Hotwheels™ Pinball GI Epic 3 Wiring update

With the new software update set to release on the week of the 6/29/2020 the location of the wire that drives GI EPIC 3 on the right side of the playfield needs to be replaced as per the instructions below.

Figure 1: Hotwheels Playfield Bottom

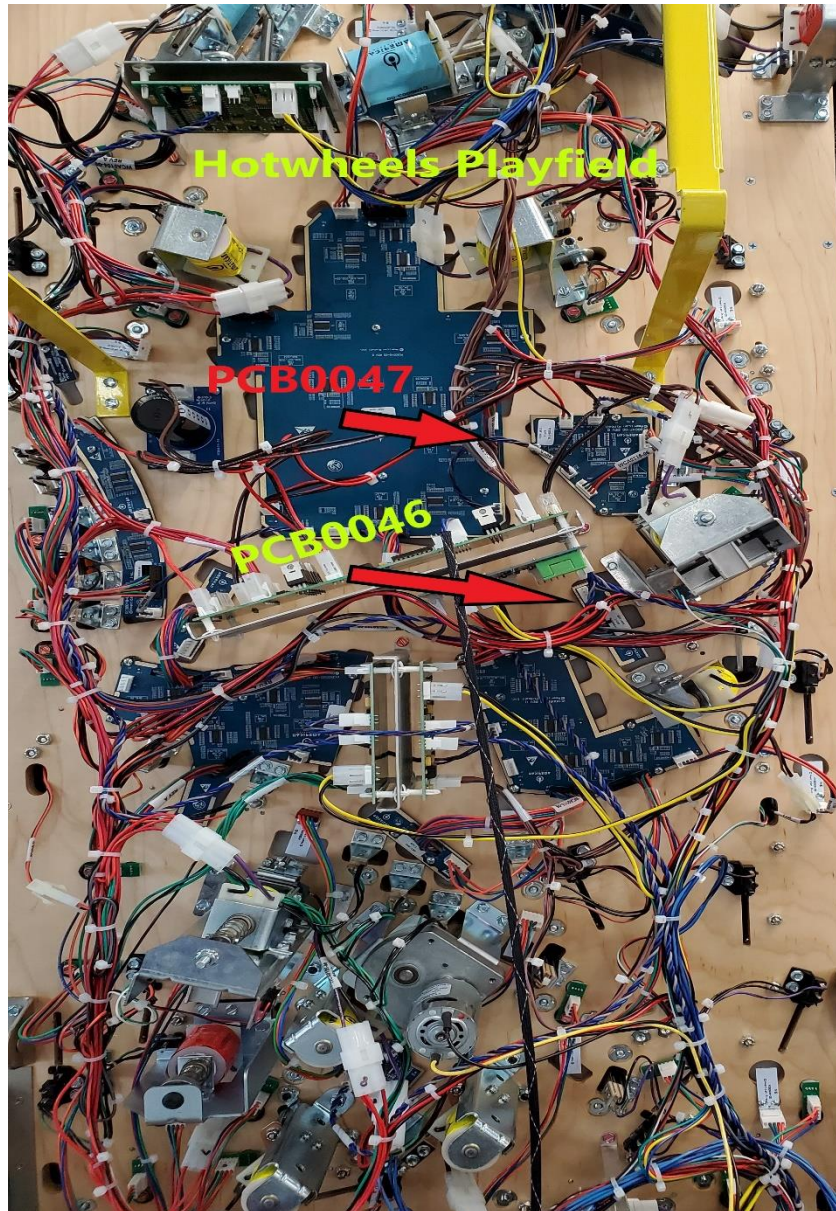
- 1) After turning off the Mains power to the pinball machine Open the playfield glass and place it on a secure area.
- 2) Lift the playfield up and locate the PCB0047 and PCB0046 as per the below picture.

Figure 3: Old location of the connection

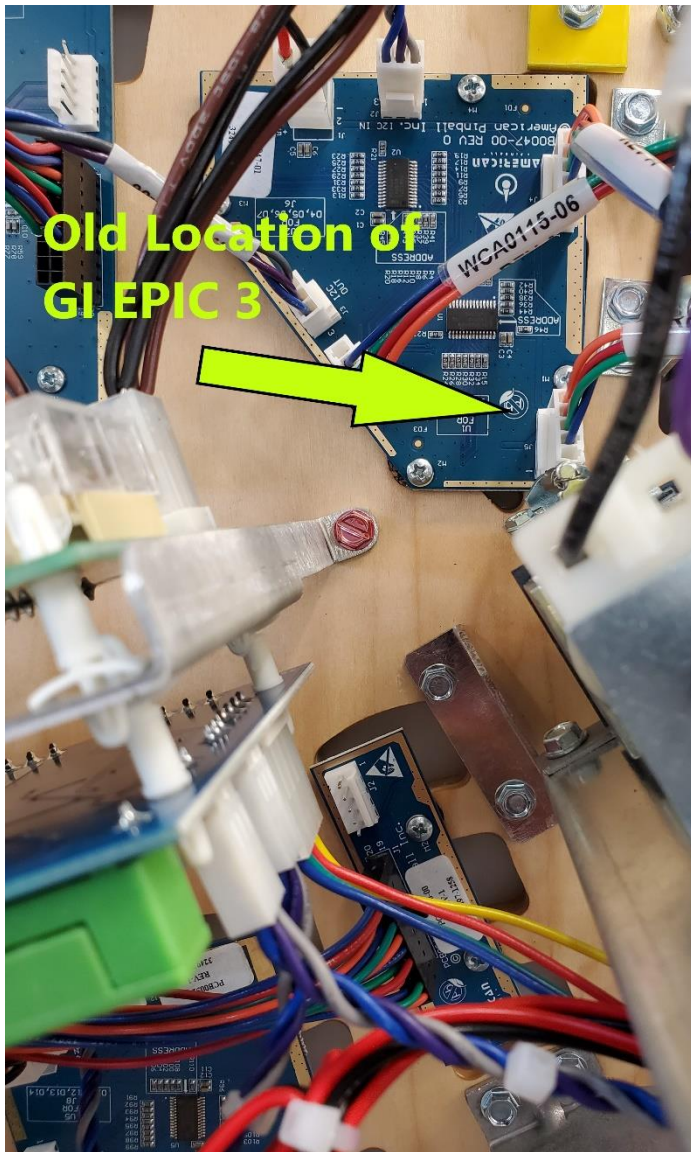
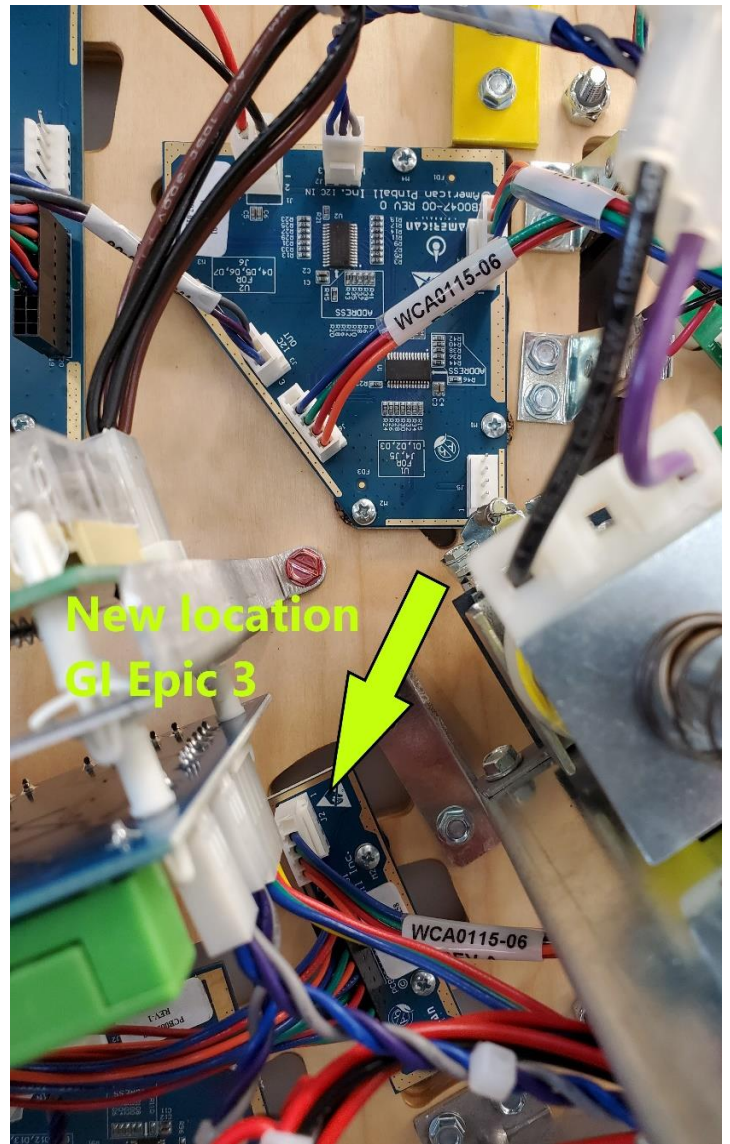
- 3) Take off the connector from the old position on PCB0047 on connector J5 as shown in the picture and replace it to the PCB0046 connector J2.

Figure 4: Assembly screw locations

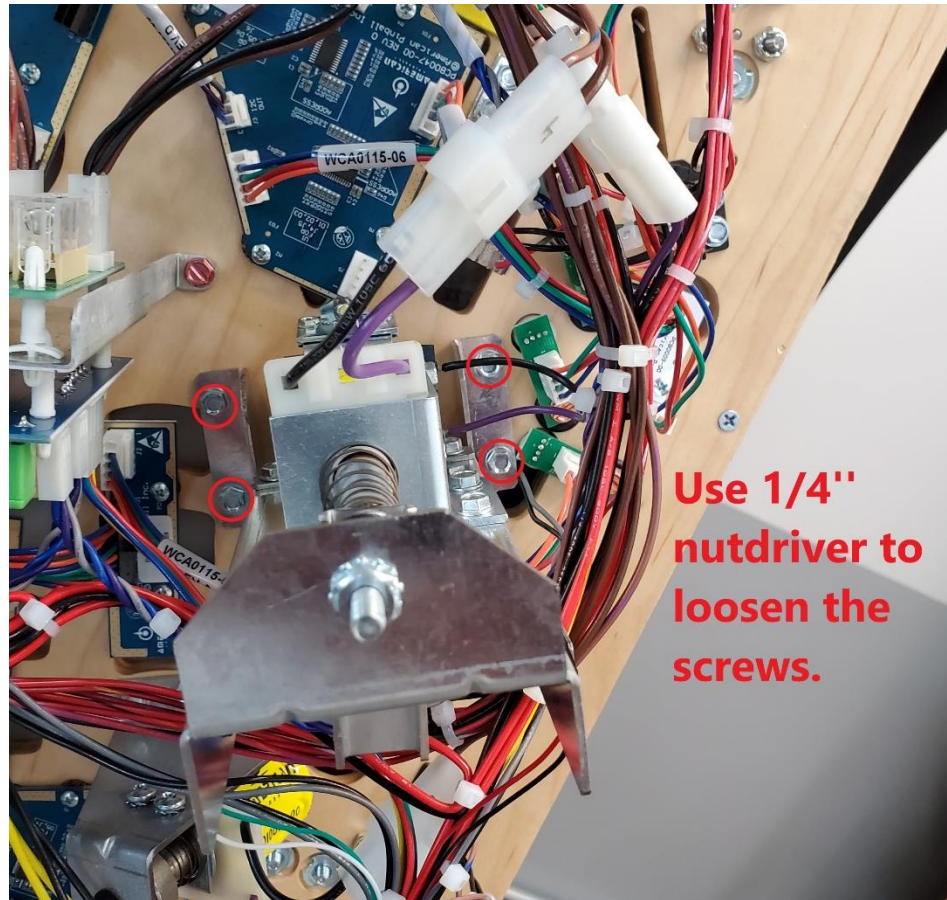
- 4) During this process of wiring change if the drop target assembly is in the way and if there is not enough room to pull the connection off then you can loosen up the assembly using $\frac{1}{4}$ " nut driver and it will give enough room to disconnect the wires.
